March 3, 2000
Contract No. NRC-02-97-009
Account No. 20.01402.861

Subject: Transmittal of "Analysis of Niche Studies and Development of Bases for Total System Performance Assessment Seepage Parameters—Letter Report" (IM 1402.861.010)

**ANALYSIS OF NICHE STUDIES AND DEVELOPMENT
OF BASES FOR TOTAL-SYSTEM PERFORMANCE
ASSESSMENT SEEPAGE PARAMETERS**

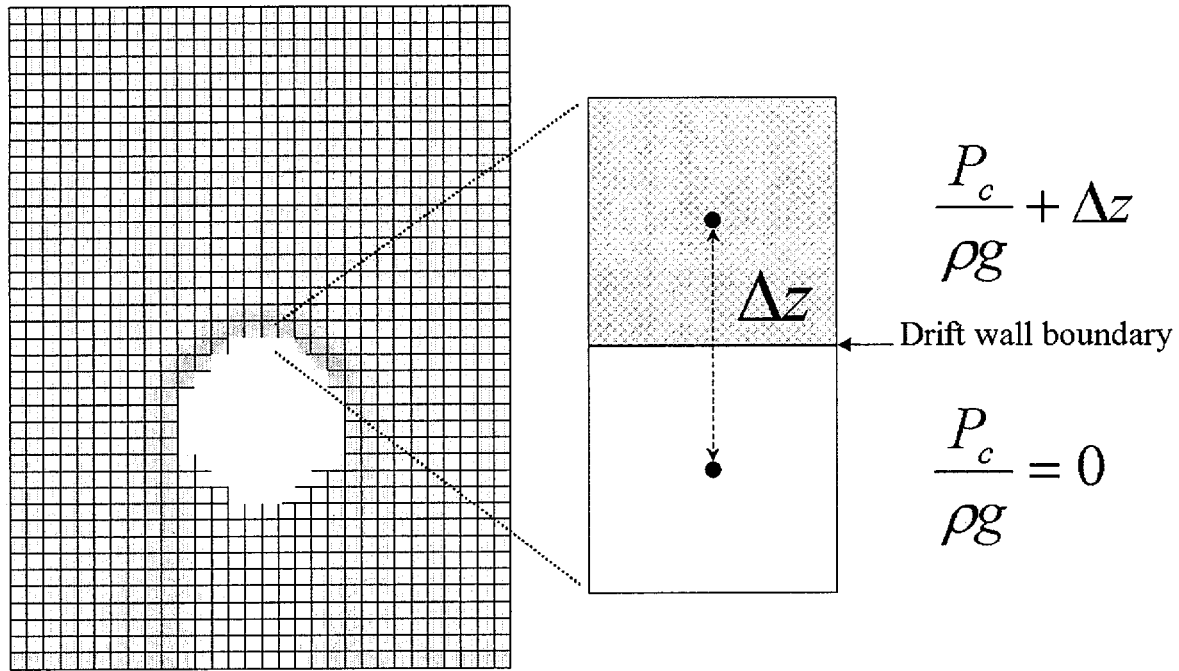
Despite incorporating comments from the DSPR, the proposed SCM still has significant shortcomings that render it inadequate to address or to bound the potential seepage volume and fraction of affected WPs. The SCM is based on small-scale (0.65 m), short-term (a few hours), high-volume liquid-release tests within the zone dried out by ventilation in the ESF. The SCM does not account for

moisture lost to evaporation during the field test, nor does it model matrix imbibition explicitly. Instead, the effect of matrix imbibition is reflected in an effective porosity obtained through inverse modeling. Nodal connections between the mesh elements of the SCM and the niche ceiling boundary are arbitrarily set to 0.05 m. Model calculated seepage into drifts is sensitive to the distance between the drift wall boundary and the node of the element immediately above.¹ Seepage flux will cross the drift wall boundary when saturation at a point just inside the rock formation reaches 1.0. Defining the drift crown as a reference elevation for convenience, this occurs when capillary pressure and total potential in the rock at the drift crown are zero. By connecting the mesh element node to the boundary with a nonzero vertical component, a gravity term equal to this vertical distance is added to the total potential (figure 2-2). Thus, seepage will cross the drift wall boundary when the pressure immediately inside the rock formation plus this gravitational term slightly exceeds the pressure inside the drift. This results in flux crossing the drift wall boundary at model saturation in the rock less than 1.0. Consequently, an α parameter determined by inverse modeling to match test data of seepage flux with a nonzero vertical connection distance between the drift wall boundary and the mesh element node is merely a fitting parameter that has no physical meaning or relationship to fracture characteristics such as aperture. Treating α as a fitting parameter to be adjusted through inverse modeling may still produce acceptable results but probably only if the inverse calibration is to data representing conditions expected in the repository following the thermal period. The α parameter calibrated in this manner, however, is specific to the grid used for the inverse modeling.

The SCM is based on the conceptual model of lateral flow diversion due to capillarity. The lowest seepage threshold obtained from the SCM calibrated to liquid release data was approximately 250 mm/yr. According to the theoretical model of Philip et al. (1989), seepage threshold is inversely proportional to both the α parameter and the cavity size. Using Philip's theoretical model, a cylindrical cavity of radius 2.0 m in a porous media continuum characterized by an exponential relative hydraulic conductivity α parameter of 0.015 Pa^{-1} and permeability of $2.5 \times 10^{-13} \text{ m}^2$ would have a seepage threshold of 260 mm/yr. Reducing the cylindrical cavity radius to 0.25 m in the same porous media continuum increases the seepage threshold to 2,000 mm/yr. For a spherical cavity of radius 0.25 m in this porous media continuum the seepage threshold is even higher, approaching 4,000 mm/yr. These numbers are not exact nor do they necessarily apply to YM. They are intended only to illustrate that the SCM calibrated to liquid-release tests implies that water could never enter cavities the size of lithophysae. There is, however, abundant evidence that water has infiltrated into lithophysal cavities from deposits of secondary minerals. Evidence of seepage flux based secondary mineralization is discussed in chapter 4.
